TILDEN STUDY CENTER

AHT Architects, Inc.
June 16, 1998

MEETING REPORT

Project/Number: Tilden Study Center/71601

ELEVATION ALONG STRATHMORE. (3)
NTS.

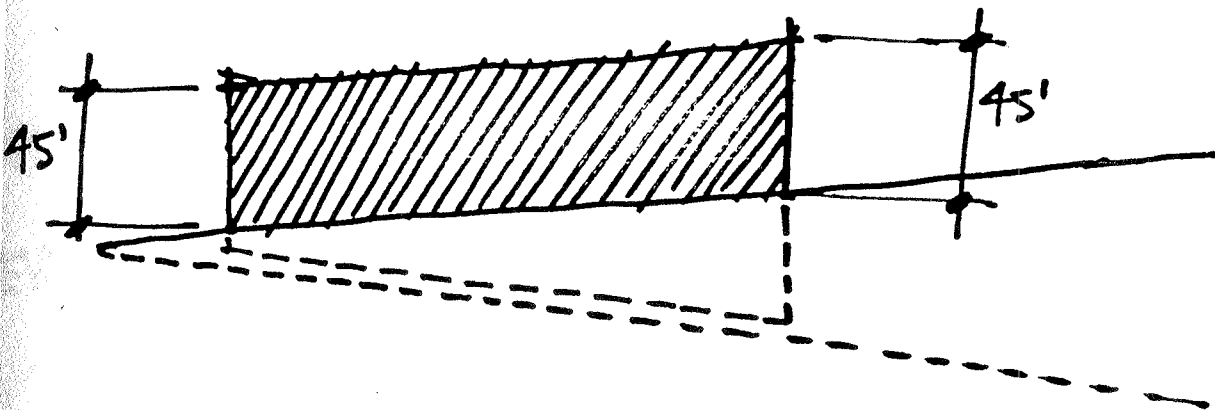
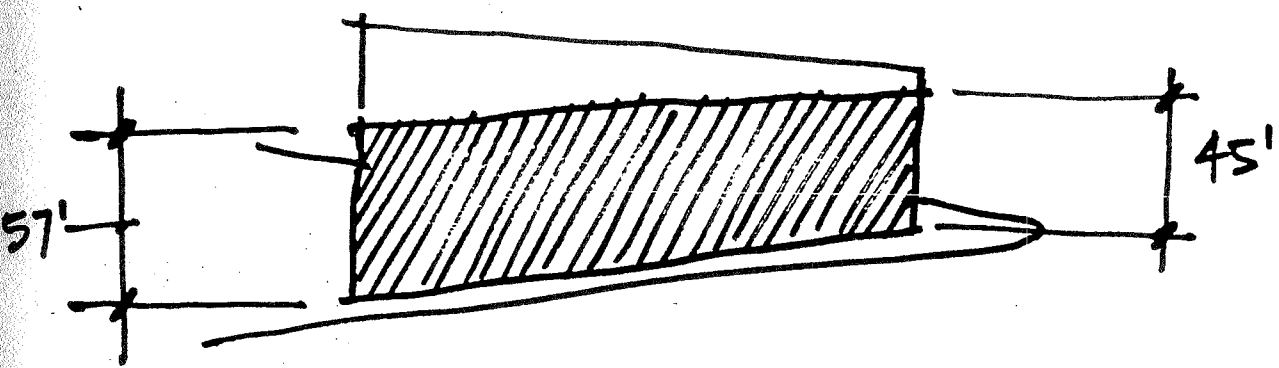
According to the North Westwood Village Specific Plan (NWV) and the L.A. Municipal Code (LAMC), the maximum height of any building on the Tilden Study Center site may not exceed 45ft. LAMC exception 12.21.1 - B2 states that if the distance measured from an exterior building wall to grade exceeds 20ft, the building may exceed the maximum height by an additional 12ft.

LADCP indicated that their interpretation is that a 45ft height restriction shall be measured as a line parallel to the inclined grade, with an additional 12ft allowed at the low end of the site; that is, a 45ft height restriction along Strathmore and a 45ft height restriction along Levering except at the low point, where the maximum height shall be 57ft. (See attached sketches)

DORMITORY / GUEST ROOM.

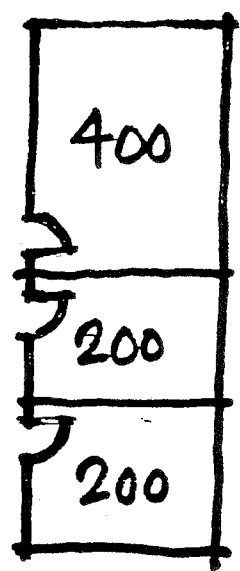
LADCP and AHT agreed that the guest rooms of the Tilden Study Center program are not all necessarily dormitories. The municipal code definitions suggest a dormitory is a room designed for more than two people. Therefore, a single room designed for one or two people and/or consisting of 200sf or less may be considered a single bedroom. The number of "guestrooms" for dormitories would then be calculated at one guestroom per each 100sf of dormitory. The attached sketch and calculations show the interpretation as agreed upon by AHT and LADCP.

400 SF = DORM ROOM
200 SF = SINGLE GUESTROOM

400 ÷ 100 = 4 GUESTROOMS
200 = 1 GUESTROOM
200 = 1 GUESTROOM

TOTAL = 6 GUEST ROOMS
